Request	-	Minor Site Plan Review
Location	-	847 W Alexis Road
Applicant	-	Larry Wilson 3108 Vestal Parkway East Vestal, NY 13850
Owner	-	JLS Alexis LLC 3440 Secor Road Toledo, OH 43606
Engineer	-	Moises Lozano Toth Associates 1550 E. Republic Road Springfield, MO 65804

APPEAL OF CONDITIONS OF APPROVAL
MINOR SITE PLAN REVIEW
TOLEDO CITY PLAN COMMISSION
REF: SPR-15-24
DATE: August 8, 2024
TIME: 2:00 P.M.

Exhibit “A”
New Draft Minor Site Plan Review Approval

RE: Minor Site Plan Review for a new drive-thru coffee shop at 847 W. Alexis Road
PC File: SPR-15-24

C2.1
SITE PLAN

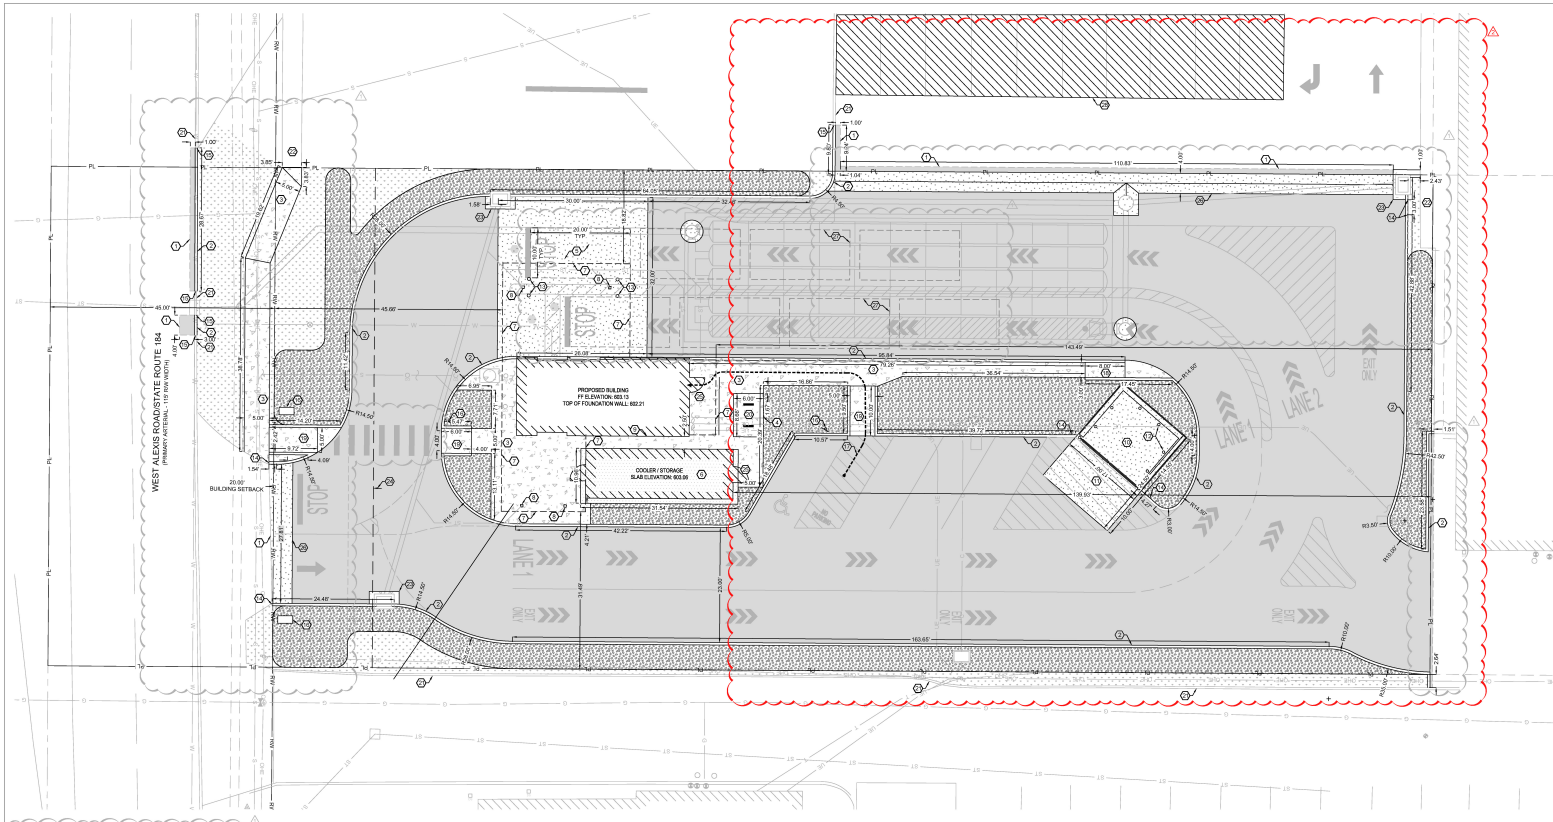
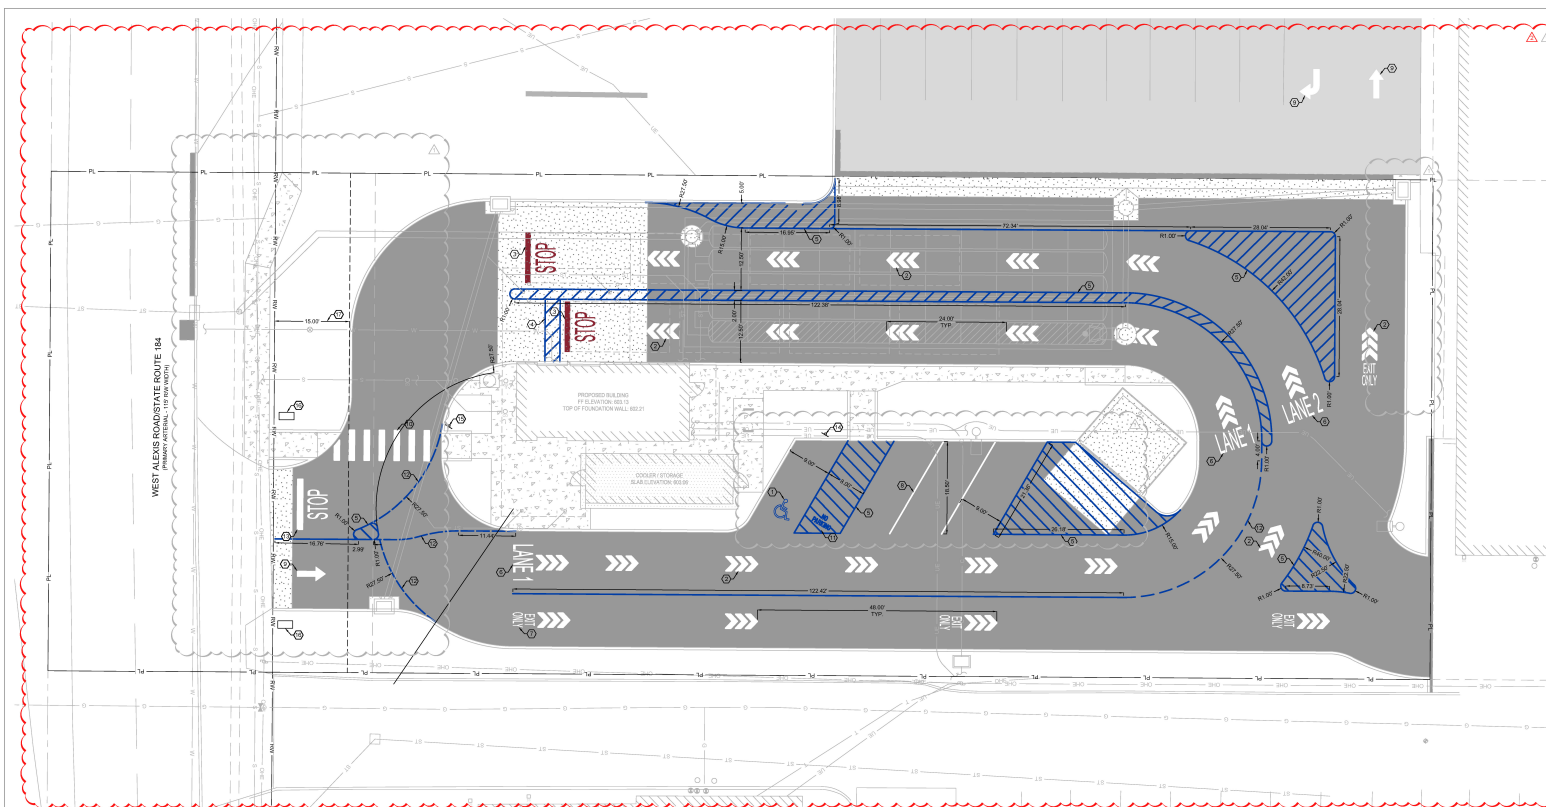
The applicant is requesting that a five-foot (5') perimeter landscape be accepted in lieu of the ten-foot (10') requirement. They are proposing to compensate for these shorter perimeter landscaping areas by placing additional plantings within the interior landscaping island. Staff finds this compromise acceptable, so long as the additional plantings are placed within the landscape island required by condition 28c. The applicant also requests the use of smaller trees in the western perimeter landscaping due to existing overhead utility lines. Staff finds this acceptable as well.

The applicant contends that a landscape island in this striped area will create an obstruction causing large vehicles, trash collection trucks, and emergency vehicles to have a difficult time navigating the site. Staff consulted with the Fire Prevention Bureau regarding this condition's effect on emergency vehicle navigation. The Bureau did identify a potential issue; however, this can be rectified by widening the "Pass Thru" lane, now labeled the "Exit Only" lane, to twenty feet (20'). This was the only issue identified by the Bureau. As such, a condition has been added that the applicant widen the eastern "Exit Only" lane connecting to the property to the east to twenty feet (20'). A somewhat smaller landscaping island will be required in the remaining area between.

- d. A landscape buffer shall be depicted between the “Lane 2” drive aisle and a line twenty-three feet (23’) from the western edge of the parking spots depicted on the adjacent property, connecting the required ten-foot (10’) landscape buffer to the north and the required landscape island between the “Lane 2” and “Pass Thru” drive aisles. This landscape buffer shall be covered with hardwood mulch, grass or other vegetative ground coverage. Shrub and/or native grass plantings are encouraged but not required within this landscape buffer. **Not acceptable as depicted. A revised site and landscape plan shall be submitted depicting a landscape buffer between the “Lane 2” drive aisle and twenty-three feet (23’) from the western edge of the parking spots depicted on the adjacent property.**

22. Van-accessible spaces must have at least an 8-foot wide aisle abutting the designated parking space. **Not acceptable as depicted. A revised site plan shall be submitted depicting an 8-foot wide aisle abutting the designated accessible parking space.**

25. The eastern "Exit Only" drive aisle shall be widened to twenty feet (20') in width per the 2017 Ohio Fire Code §503.2.4. **Not acceptable as depicted. A revised site plan shall be submitted depicting the eastern "Exit Only" drive aisle widened to twenty feet (20').**

The applicant submitted revised plans with their appeal, which included the addition of a drive connection to the south in accordance with the easement described above and the relocation of the dumpster to accommodate said connection. The revised plans were routed to the Division of Traffic Management and the Fire Prevention Bureau for comment. Relevant conditions will be revised in a new administrative Minor Site Plan Review approval, which the Plan Director will issue following this appeal's hearing. The draft of this approval is attached as Exhibit A.

The applicant has reduced the number of parking spaces on-site and revised their parking lot calculations to include the ten (10) parking spaces provided on the adjacent property. The easement with the adjacent property states "that the owner of the [applicant's] Parcel may not include such spaces when determining whether the [applicant's] Parcel has sufficient parking to meet all code requirements." The removal of those ten (10) spaces from the site's code-required parking calculation is beneficial to the applicant considering TMC§1107.0302 *Maximums*, which states: "No use may provide more than 150 percent of any of the minimum off-street parking ratios of Schedule A, except through approval of an Alternative Parking Plan pursuant to Section 1104.0100. This provision notwithstanding, Alternative Parking Plan approval is not required for four or fewer parking spaces." Schedule A requires a minimum of two (2) spaces for the proposed coffee shop – 150% of which is three (3) spaces. Since the revised site plan shows four (4) parking spaces – and the ten (10) provided just off site are not counted – the applicant complies with TMC§1107.0302 *Maximums*. This condition has been revised as such in the attached draft minor SPR approval.

C5.1
LANDSCAPE PLAN

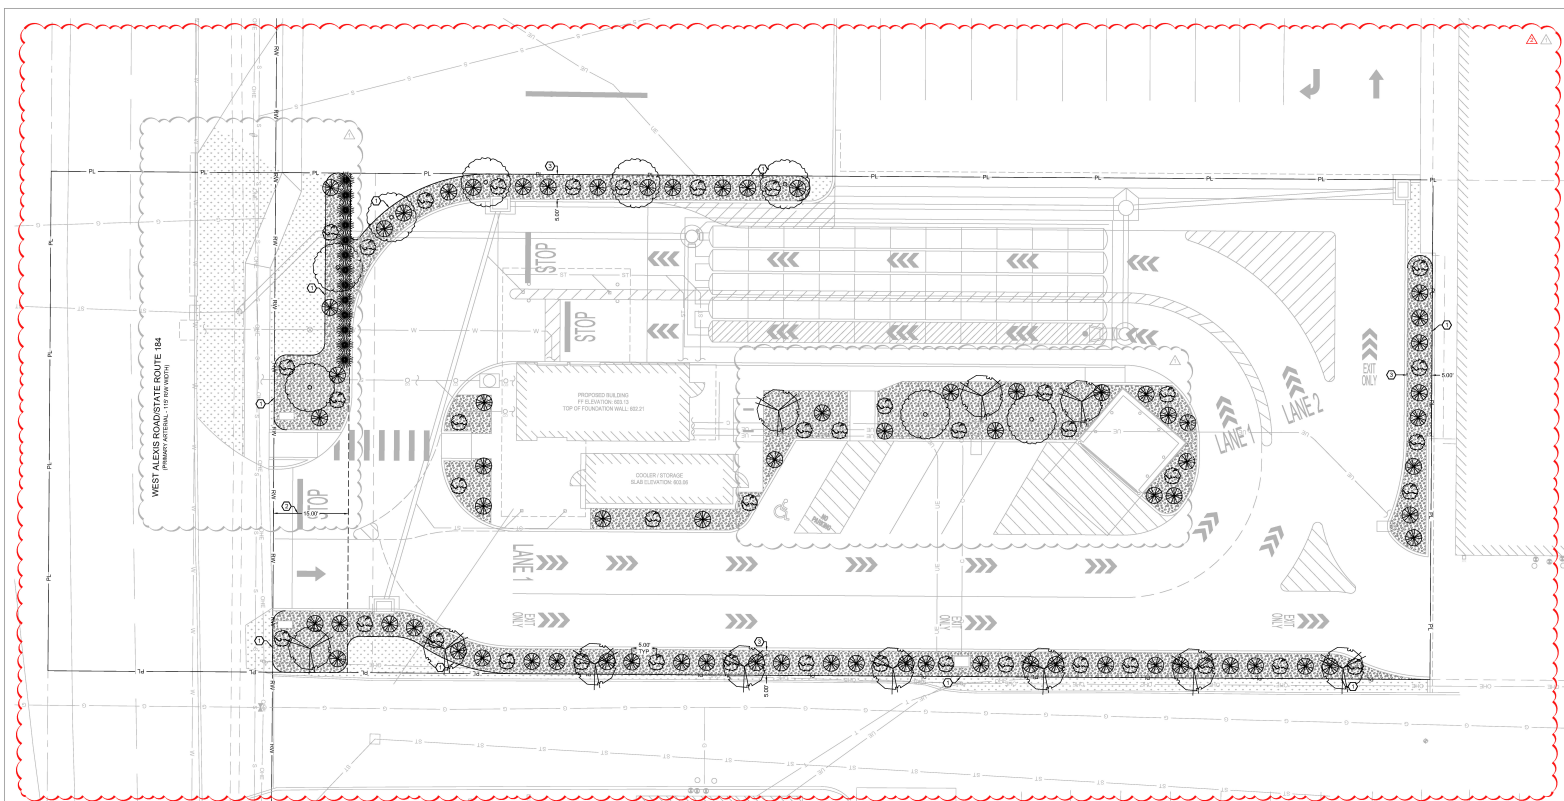
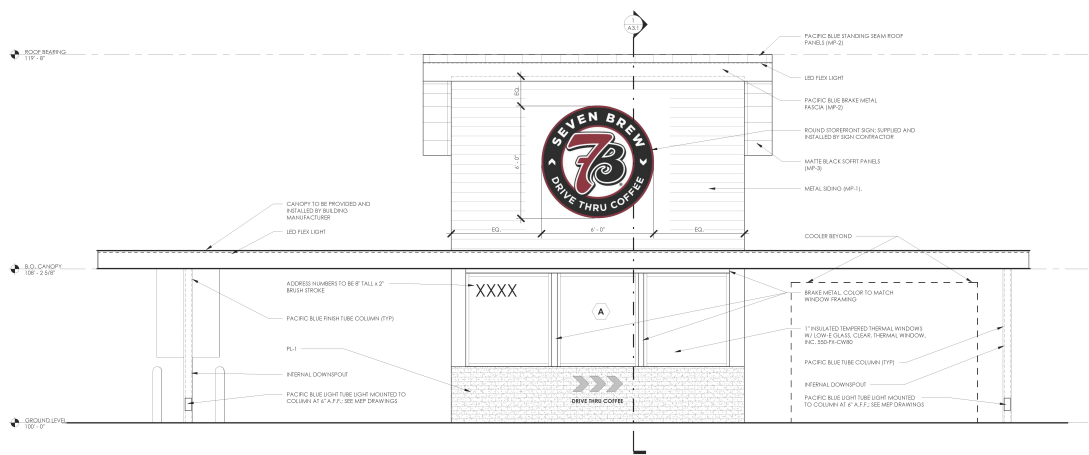
- c. A landscape island shall be depicted in the area between the "Lane 2" and "Pass Thru" drive aisles to break up the urban heat island. This landscape island must be covered with hardwood mulch, grass or other vegetative ground coverage. Tree and shrub plantings are encouraged but not required within this landscape island. **Not acceptable as depicted. A revised site and landscape plan shall be submitted depicting a landscape island between the "Lane 2" and "Pass Thru" drive aisles.**

- b. Perimeter landscaping must be installed along any parking lot area adjacent to a street, place, or driveway, or which is visible from an immediately adjacent property. Perimeter landscaping must consist of a landscape area at least 10 feet in width, exclusive of sidewalks, walkways, trails, or right-of-way and must be located between the parking lot and the property line. A minimum of at least one (1) canopy tree must be provided for each thirty feet (30'), plus a continuous shrub with a minimum height of 18 inches (when installed so as to achieve full screening at maturity) **Not acceptable as depicted. Perimeter landscape buffer may be five feet (5') in width so long as at least two (2) canopy trees and eight (8) shrubs are planted within the required landscape island between "Lane 2" and the eastern "Exit Only" lane. Two (2) additional canopy trees are required within the southern perimeter landscaping. Trees within the western perimeter landscaping may be smaller trees due to existing utility lines. A revised landscaping plan shall be submitted depicting two (2) canopy trees within the southern perimeter landscaping.**

- c. A landscape island shall be depicted in the area between the "Lane 2" and eastern "Exit Only" drive aisles to break up the urban heat island. This landscape island must be covered with hardwood mulch, grass or other vegetative ground coverage. Two (2) canopy trees and eight (8) shrubs are required within this landscape island. **Not acceptable as depicted. A revised site and landscape plan shall be submitted depicting a landscape island containing two (2) canopy trees and eight (8) shrubs between the "Lane 2" and "Pass Thru" drive aisles.**

- d. A landscape buffer shall be depicted between the "Lane 2" drive aisle and a line twenty-three feet (23') from the western edge of the parking spots depicted on the adjacent property, connecting the required landscape buffer to the north and the required landscape island between the "Lane 2" and eastern "Exit Only" drive aisles. This landscape buffer shall be covered with hardwood mulch, grass or other vegetative ground coverage. Shrub and/or native grass plantings are encouraged but not required within this landscape buffer. **Not acceptable as depicted. A revised site and landscape plan shall be submitted depicting a landscape buffer between the "Lane 2" drive aisle and twenty-three feet (23') from the western edge of the parking spots depicted on the adjacent property.**

The applicant contends that a landscape buffer in this area would invalidate an easement granted on April 18th, 1994 between the applicant’s property and the adjacent property currently occupied by OfficeMax. The easement is attached to this report as Exhibit B. This easement establishes three agreements relevant to this appeal, the first of which is “a nonexclusive easement of access to be provided by means of one point of entry twenty nine (29) feet wide between the [OfficeMax] Parcel and the [applicant’s] Parcel, at the location designated on Exhibit C...” Exhibit C of the easement, part of Exhibit B of this report, shows this access easement at the south west of the property. Ingress and egress for this access easement agreement will not be impeded by the conditioned landscape strip.

A2.1
EXTERIOR ELEVATIONS

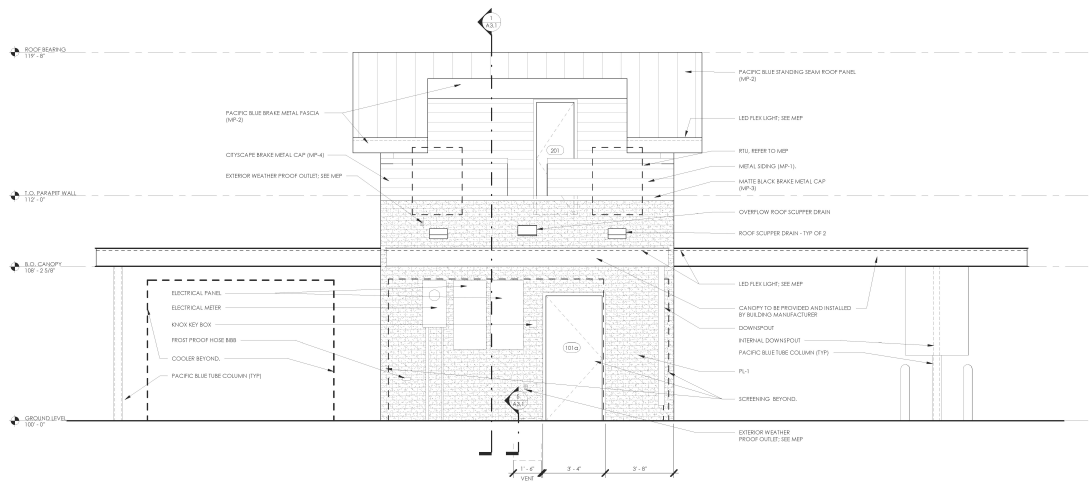
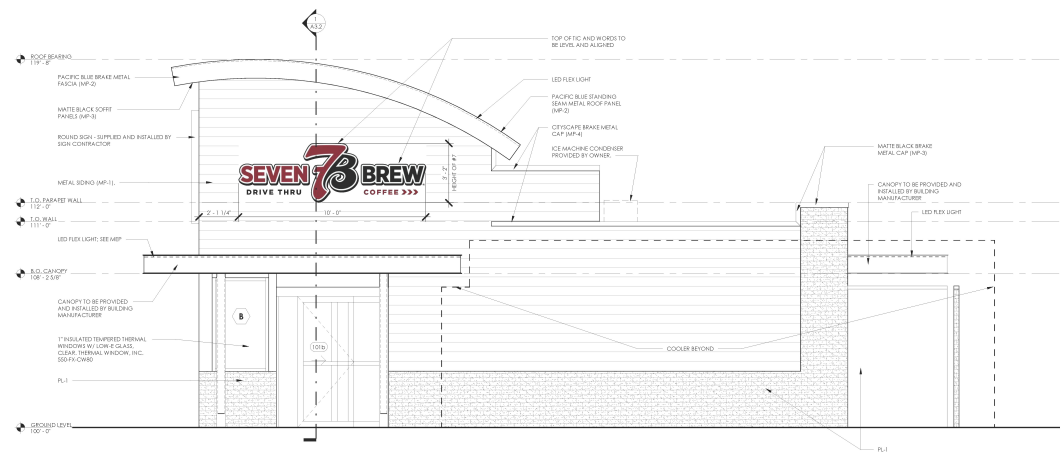
31. Predominant exterior building materials shall be high-quality materials. For façades visible from the public right-of-way, predominant materials must comprise at least eighty percent (80%) of the total wall area of the façade. **Acceptable as submitted.** *Breakdown of submitted materials are as follows, names are based on what is shown on elevation sheets:*

- A. Front elevation: 57.9% Architectural Metal, 25.7% Glass Storefront, 16.4% Brick. Glazing composes 58.9% of the elevation from 2' to 10' in height.

- D. Back elevation: 36.7% Architectural Metal, 0% Glass Storefront, 63.3% Brick. Glazing composes 0% of the elevation from 2' to 10' in height.

A2.2
EXTERIOR ELEVATIONS

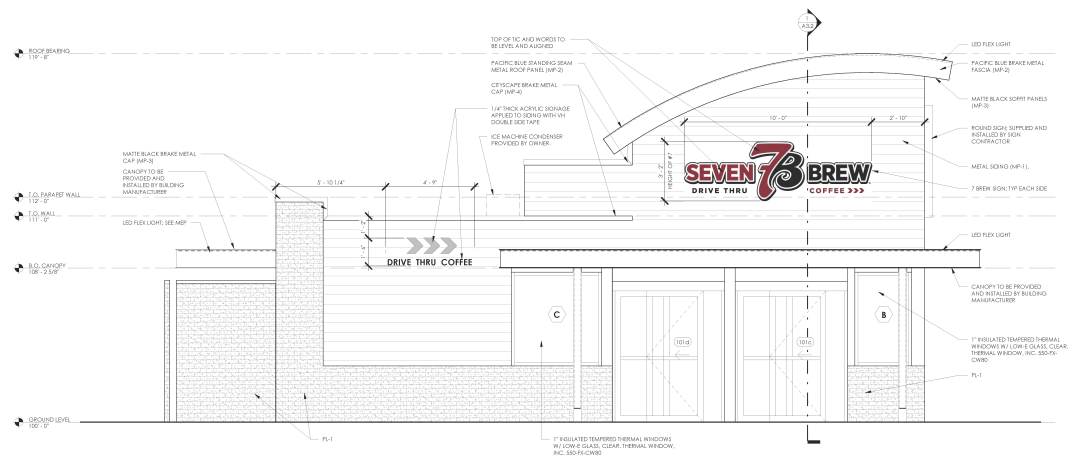
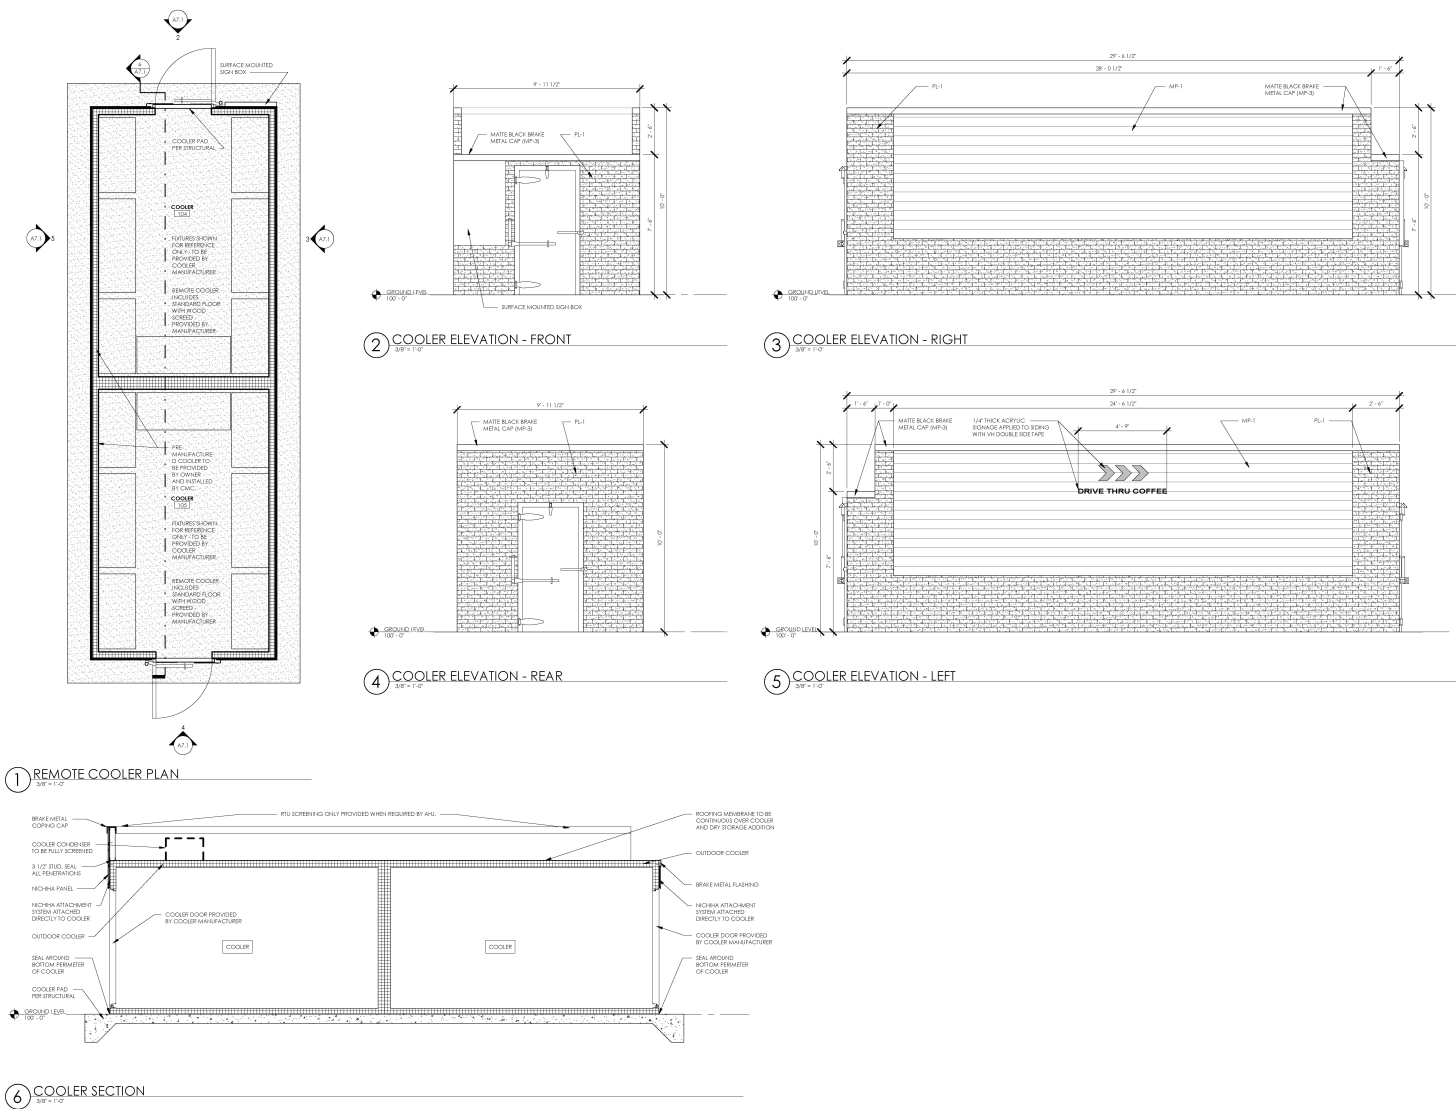
- B. Right-side elevation: 64.9% Architectural Metal, 13.4% Glass Storefront, 21.6% Brick. Glazing composes 19.9% of the elevation from 2' to 10' in height.

- C. Left-side elevation: 48.6% Architectural Metal, 27.6% Glass Storefront, 23.7% Brick. Glazing composes 40.5% of the elevation from 2' to 10' in height.
